NOTICE TO ALL FIRMS

Re: Addendum Number 2
IFB # C1576 – D442 Classroom Renovation

PROJECT:
D442 CLASSROOM RENOVATION
POMERANTZ 300 7TH AVE
NEW YORK NY 10001

4TH FL DEMOLITION PLAN
REFLECTED CEILING PLAN

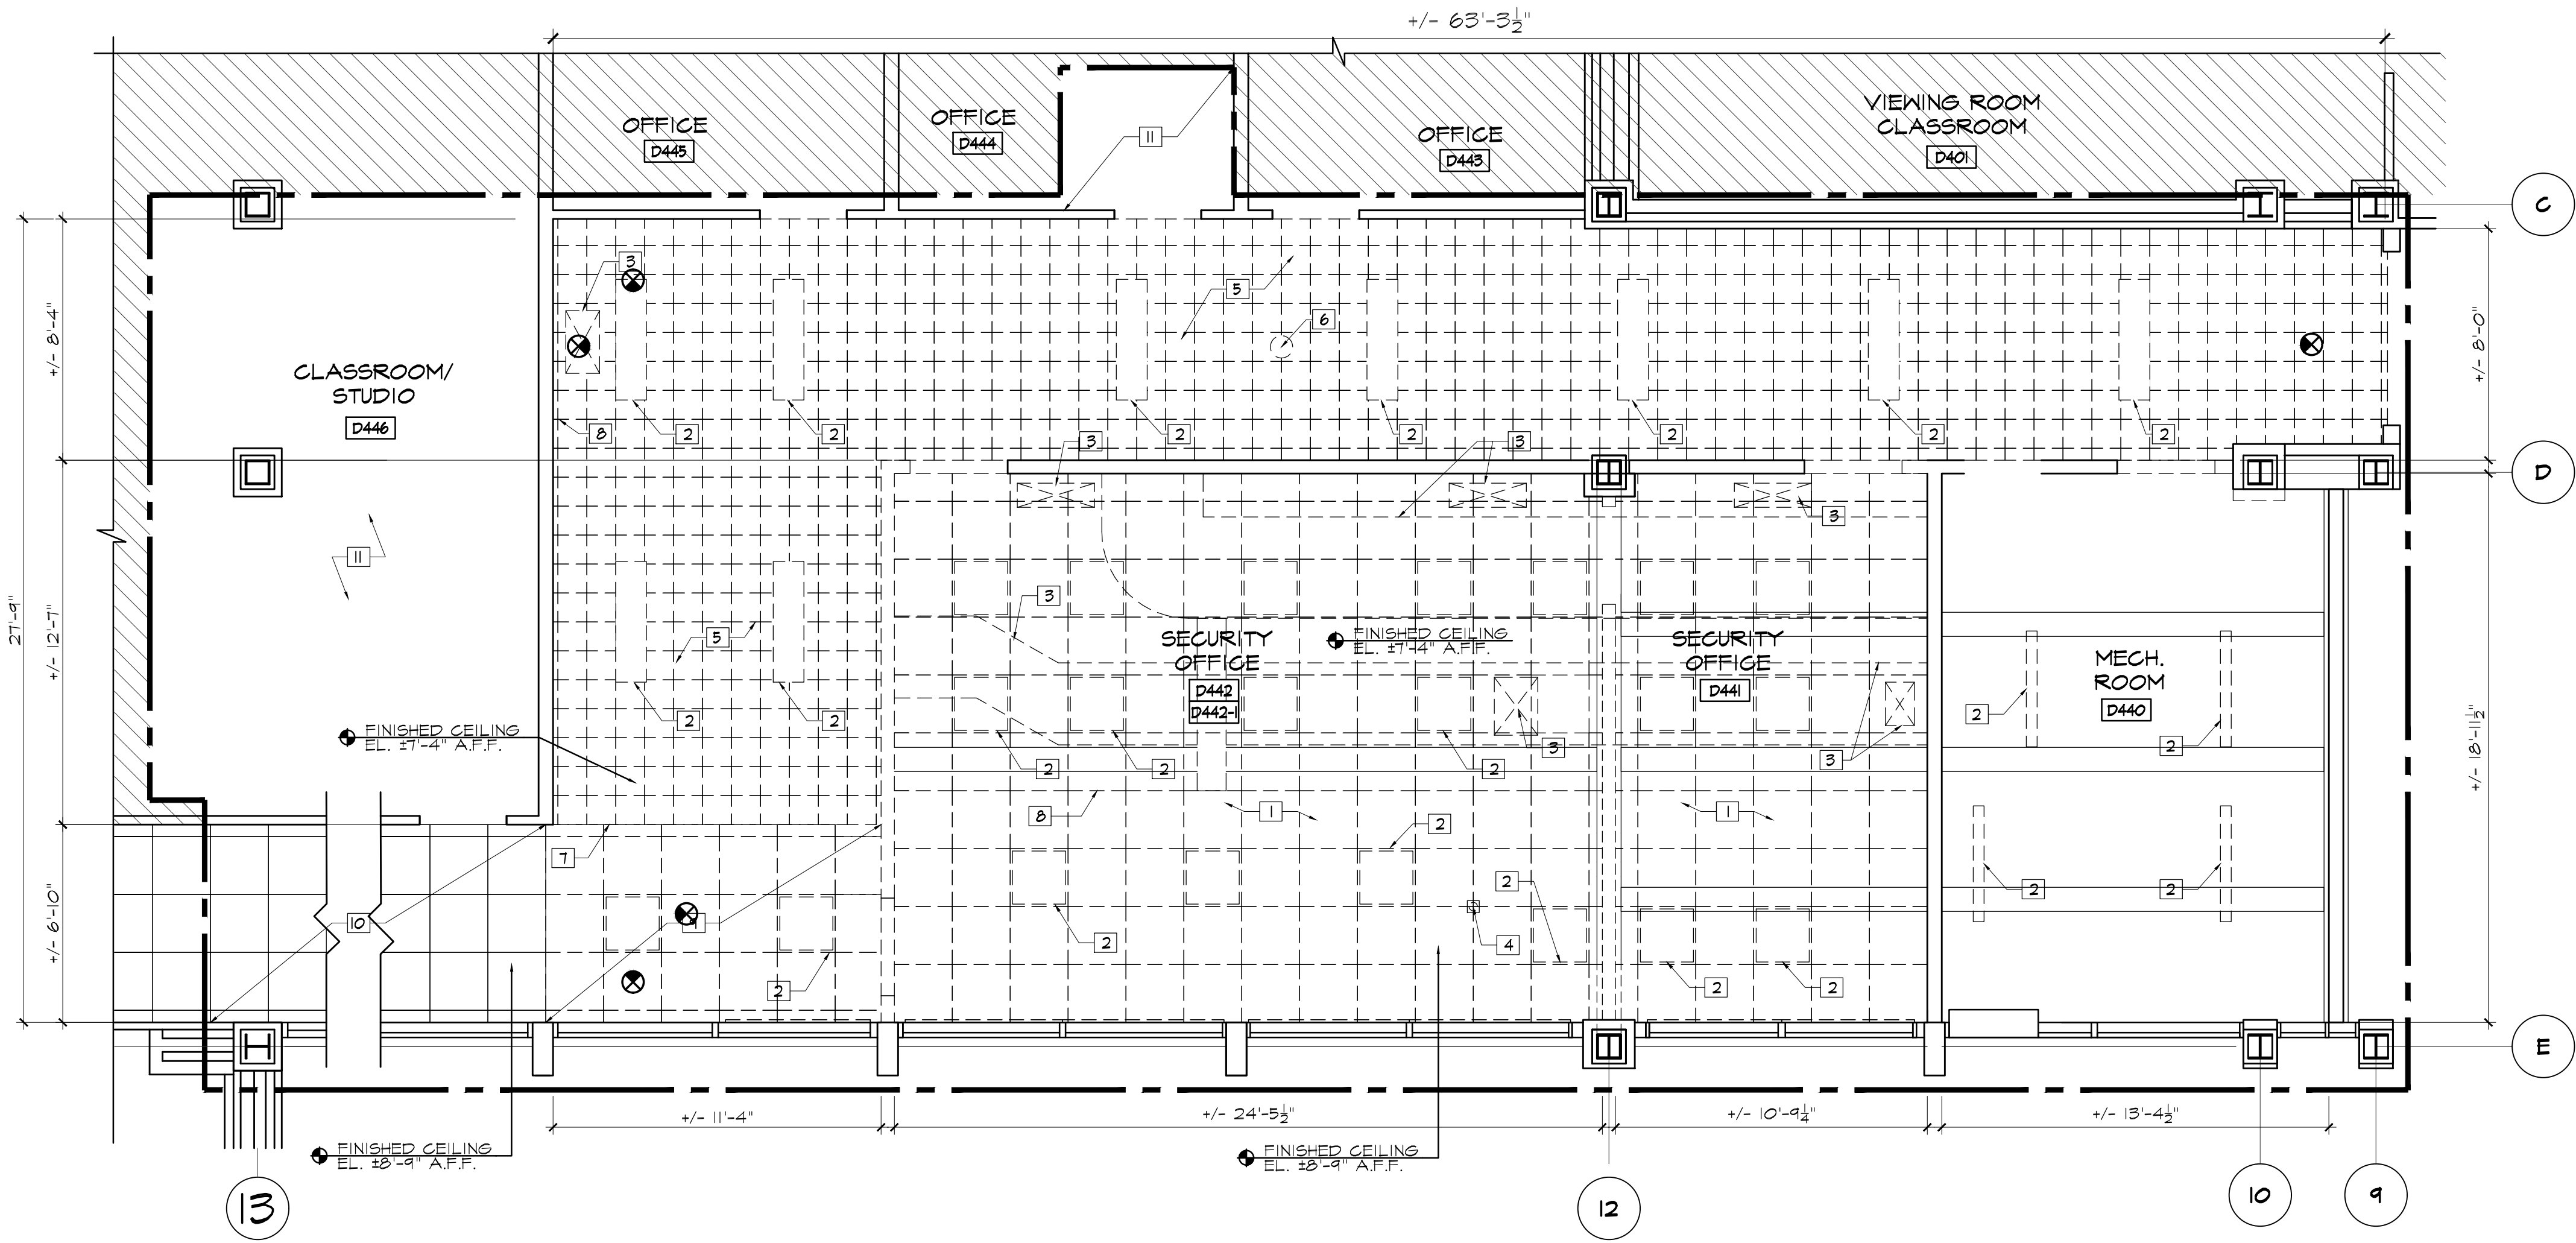
- A10. No.
- Q11. Bid drawing "DM-400", demolition note # 11 states "Existing Ceiling and Lighting to be removed and Stored for Reinstallation. Coordinate the exact demo. scope with mech. Dwgs". In contrast to this, bid drawing "A-400", Reflected ceiling plan note # 4 states "Remove & Replace existing ceiling tiles as required to complete mechanical work". Please clarify.

- A11. See attached revised DM-400.01 and A-400.01 with revised notes.
- Q12. Bid drawing "A-100", Construction plan note # 8 states "Relocated 36 existing lockers". However, the quantity of lockers depicted on the bid drawings are 24. Please clarify the exact quantity.

- 1 REMOVE ALL EXISTING 2X2 CEILING TILES, HANGERS AND SUPPORTING FRAME.
- 2 REMOVE ALL CEILING LIGHTS.
- 3 REMOVE EXIST. CEILING VENTS AND DUCTWORK, SEE MECH. DWGS FOR DETAILS
- 4 REMOVE EXIST. LIGHT SENSOR.
- 5 REMOVE EXIST. SPLINE CEILING AND ALL SUPPORTS.
- 6 FIT TO REMOVE EXIST. WIRE ACCESS POINT (WAP)
- 7 REMOVE EXIST. SOFFIT.
- 8 REMOVE EXIST. SPEAKER
- 9 EXIST. 2X2 ACT & LIGHTING TO BE REMOVED AND STORED FOR REINSTALLATION
- 10 EXIST. 2X2 ACT & LIGHTING TO REMAIN & PROTECT AS REQ.
- 11 REMOVE AND INSTALL NEW CEILING TILES AS REQUIRED TO COMPLETE MECHANICAL WORK

4H FLOOR PLAN

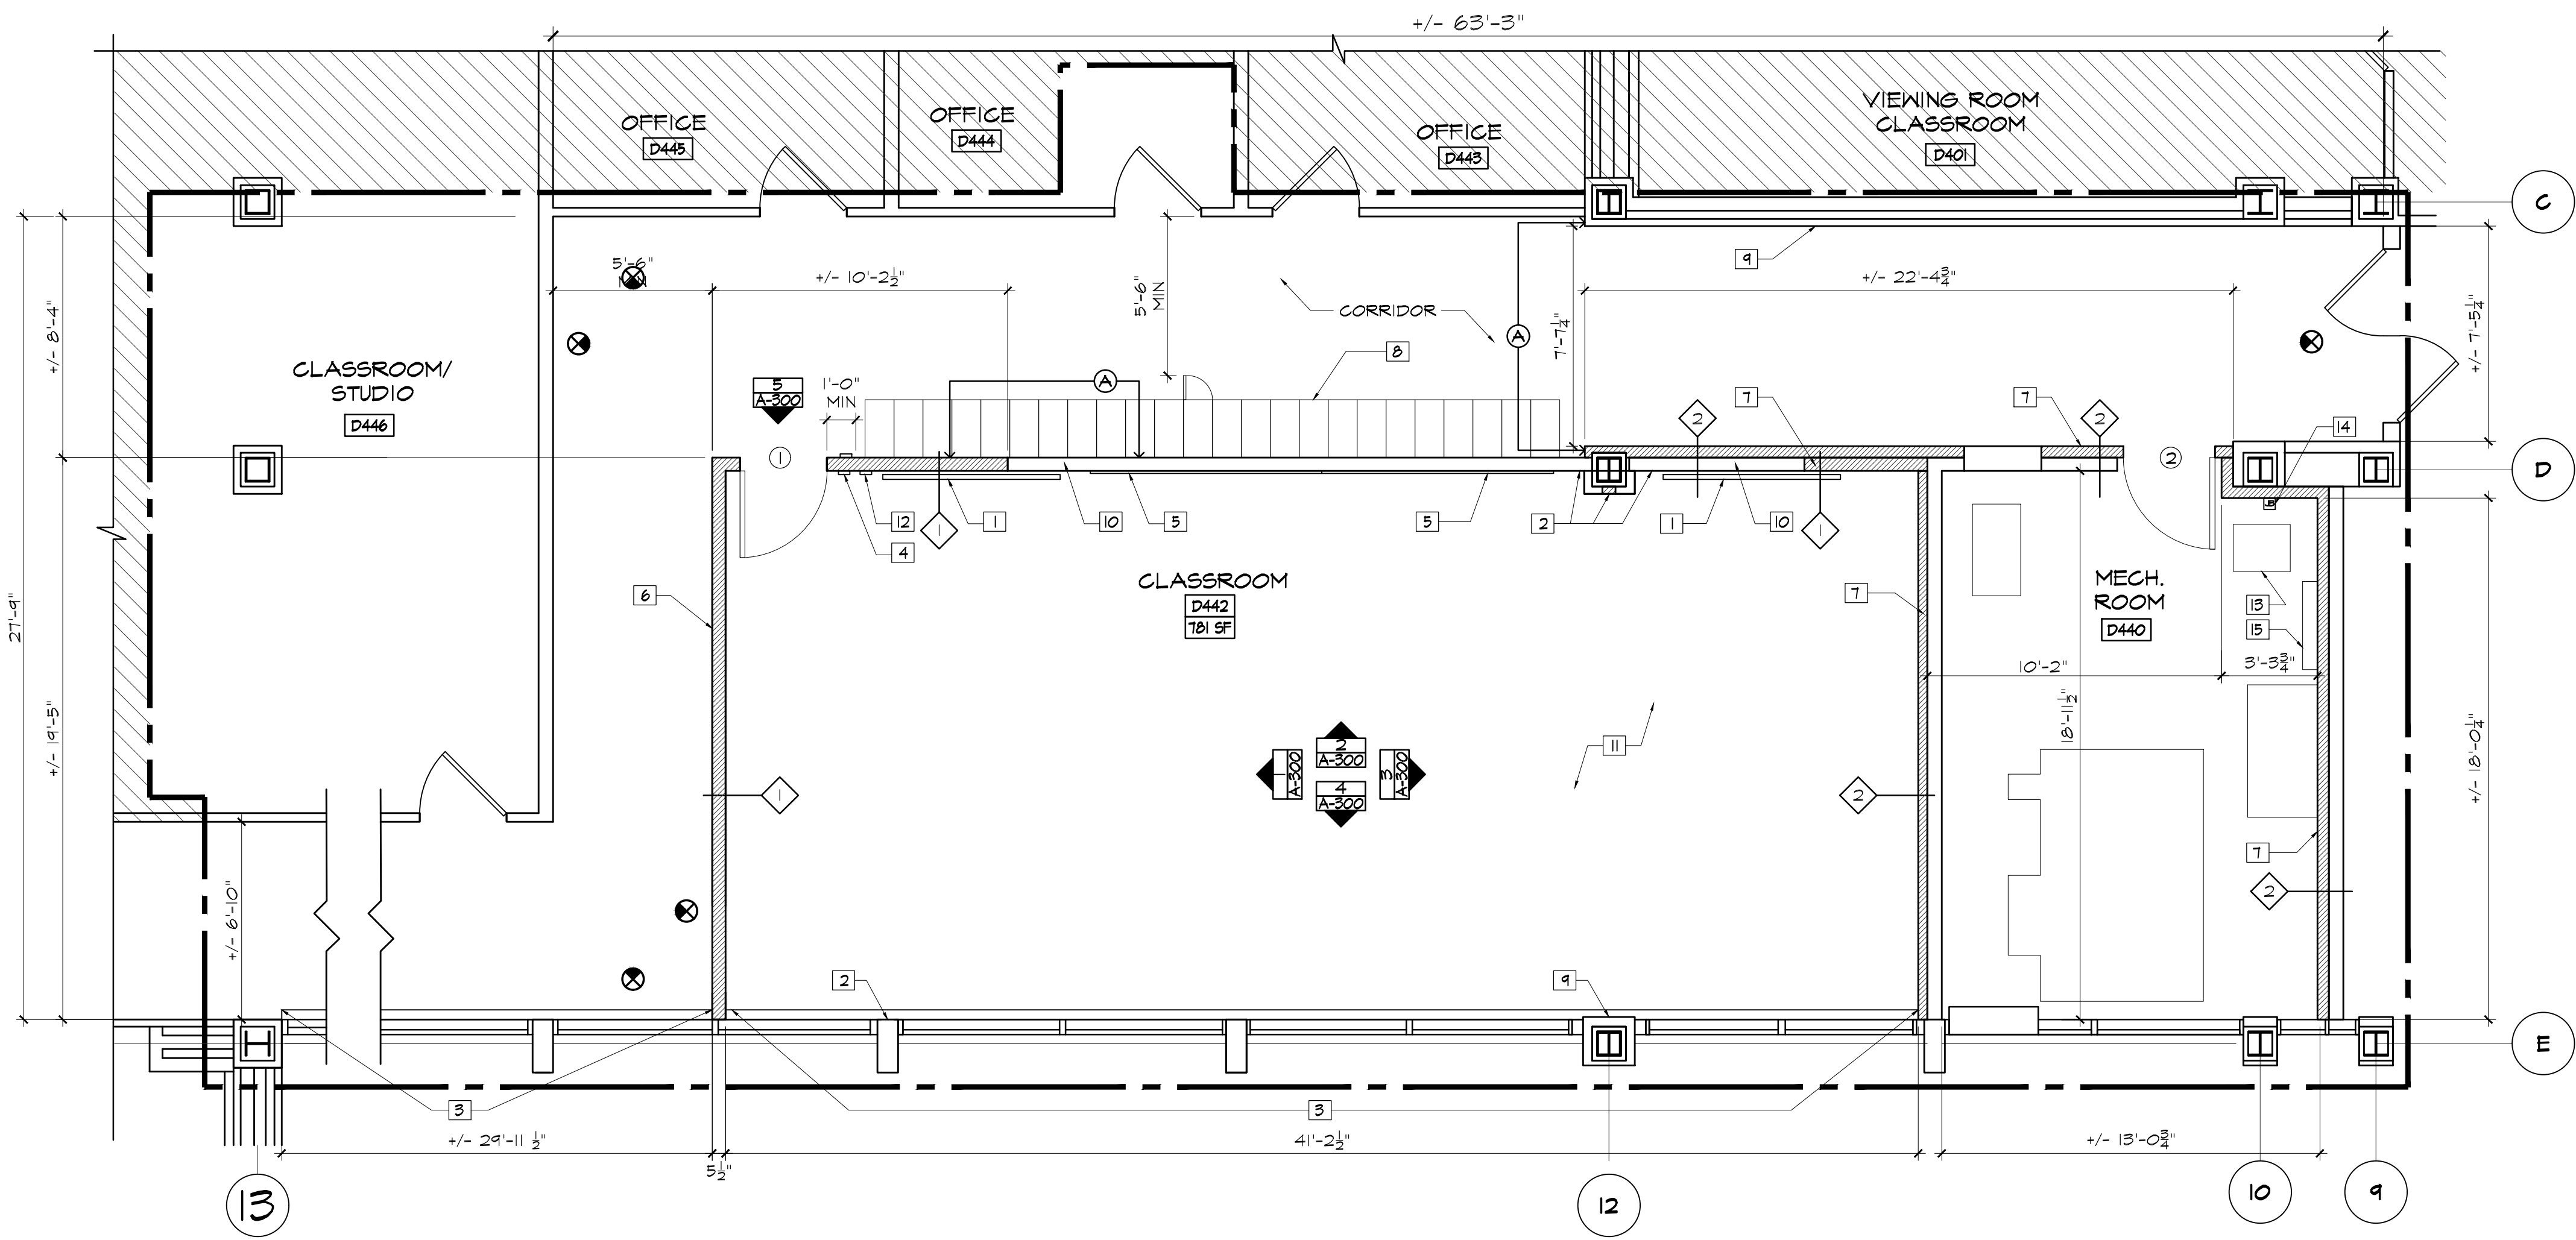
- Q2. Construction plan note 11, on drawing A-100.00, to "patch exist quarry tile floor & install self-leveling". Since the quarry tile was concealed by the existing finished floor, we cannot determine the extent of the patching that may or may not be required. How do we proceed?

- A12. 24 lockers to be reinstalled. Contractor is responsible for disposal of the remaining 12 lockers. See attached revised a-100.01 with revised notes.

7. NEW 2-HR RATED SHAFT PARTITION FURRED-OUT. PROVIDE FIRE STOPPING AT ALL RATED WALL PENETRATIONS (TYP)
8. RELOCATED 24 EXISTING LOCKERS. DISPOSE THE REMAINING 12

4TH FLOOR RCP
& LIGHTING SCHEDULE

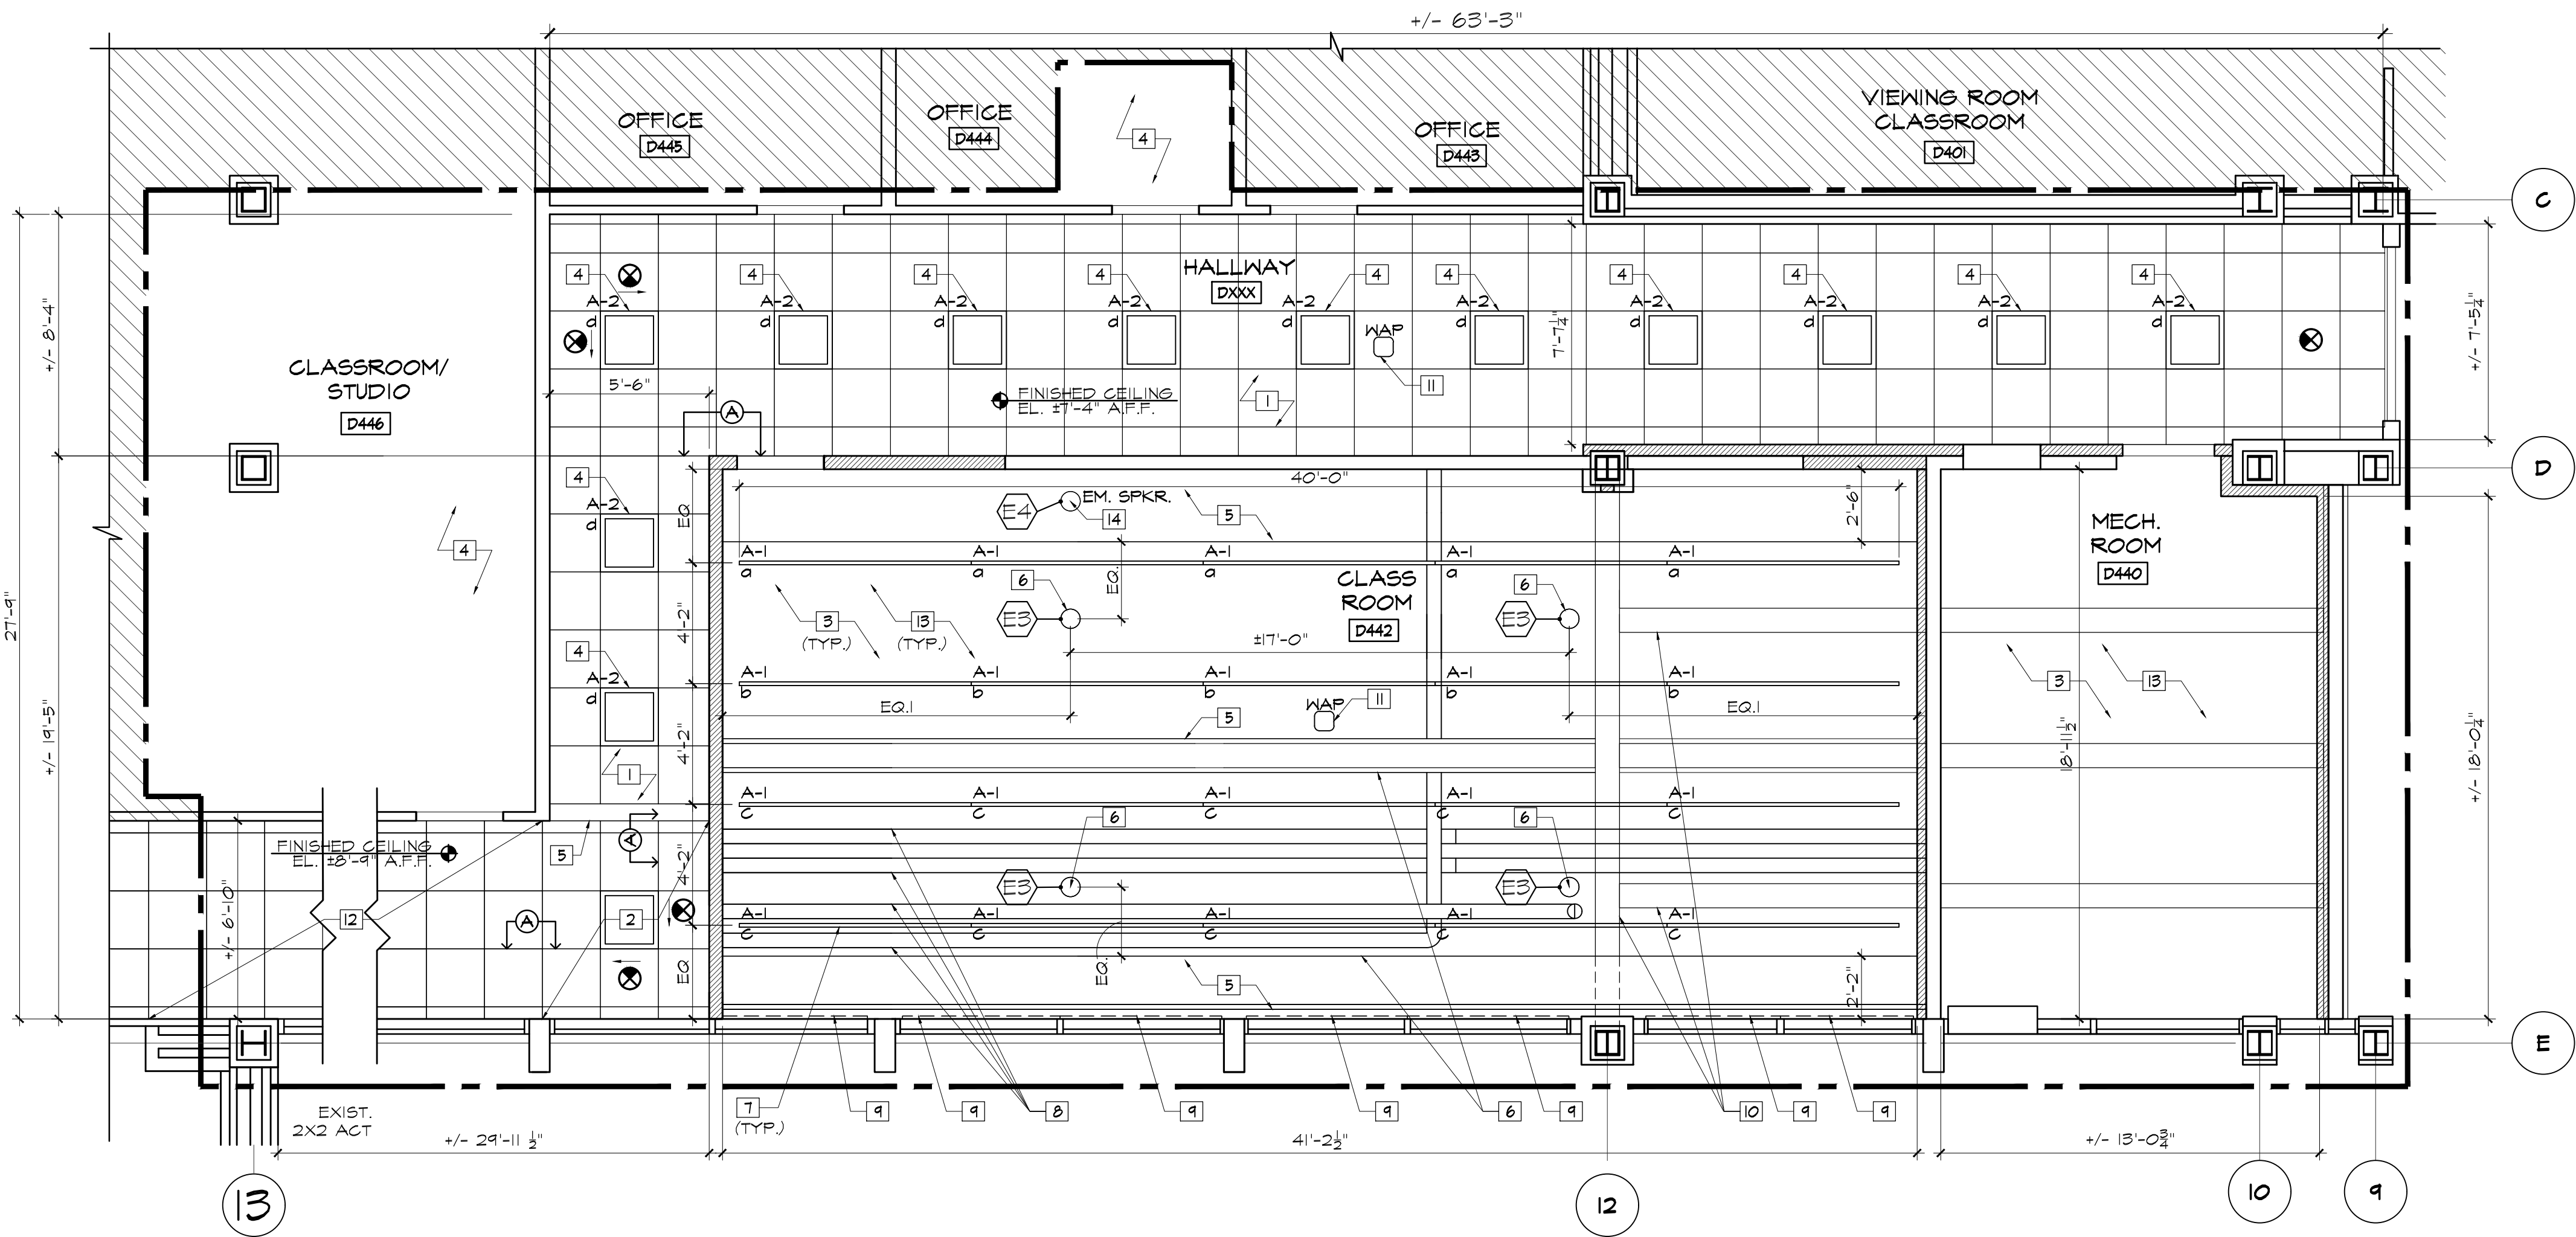
- Q4. Reflected Ceiling Plans, 3 & 11, notes to patch and repair the existing slab & beam. To what extent are these surfaces to be repaired?

- A4. On RCP Plan notes #3 and #10 call for patching and repair. These surfaces are scheduled to be painted, thus they have to be repaired and prepped to have a smooth and even appearance, to receive priming before painting.

Door Schedule

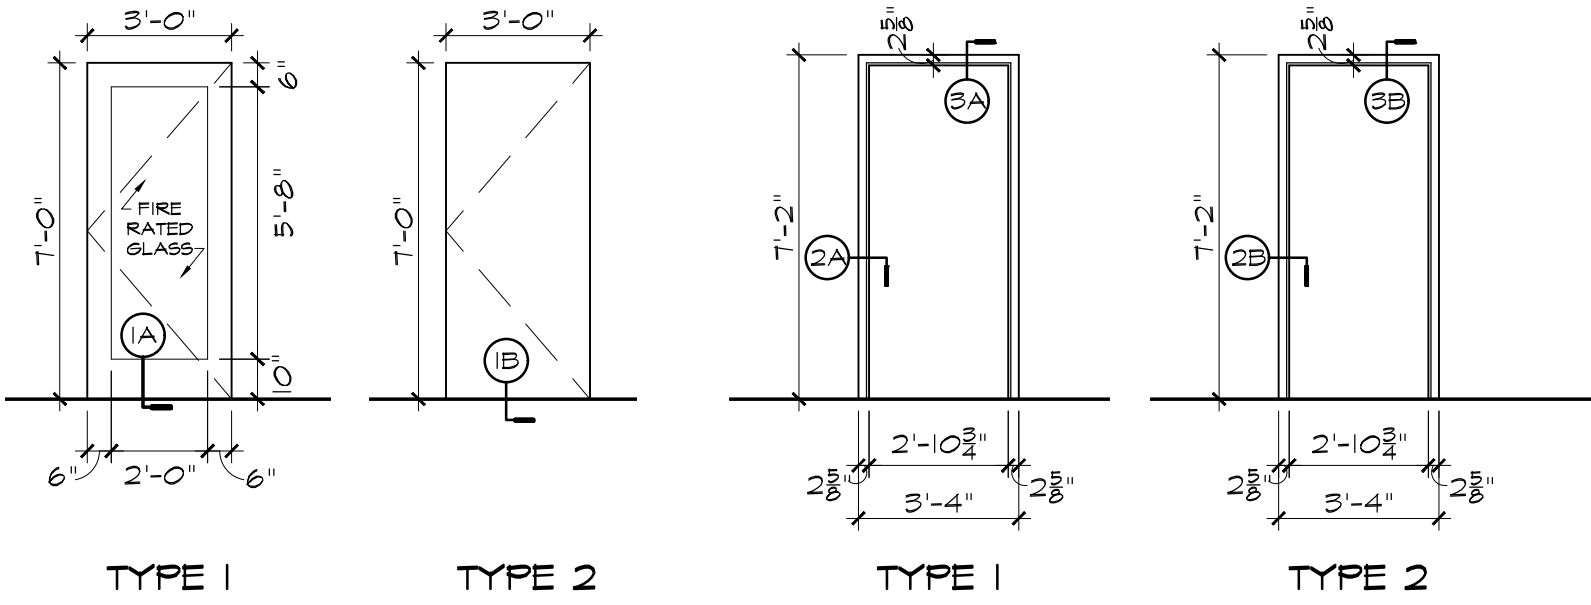
- A13. Courtesy telephone to be provided by FIT. Contractor to provide black box and empty conduit. Coordinate with FIT IT and their installer.
- Q14. Bid drawing "A-700", Door schedule specifies the thickness of corridor door 1 as 2-1/4 inch. However, the specified manufacturer has confirmed that they do not provide 2-1/4 inch thickness. Specified manufacturer has confirmed the thickness of door to be 1-3/4" inches. Please confirm.

- A14. 1-3/4" thickness is acceptable. See revised A-700.01
- Q15. a. Will FIT provide a room to GC, during the execution of project, to be used as site office?
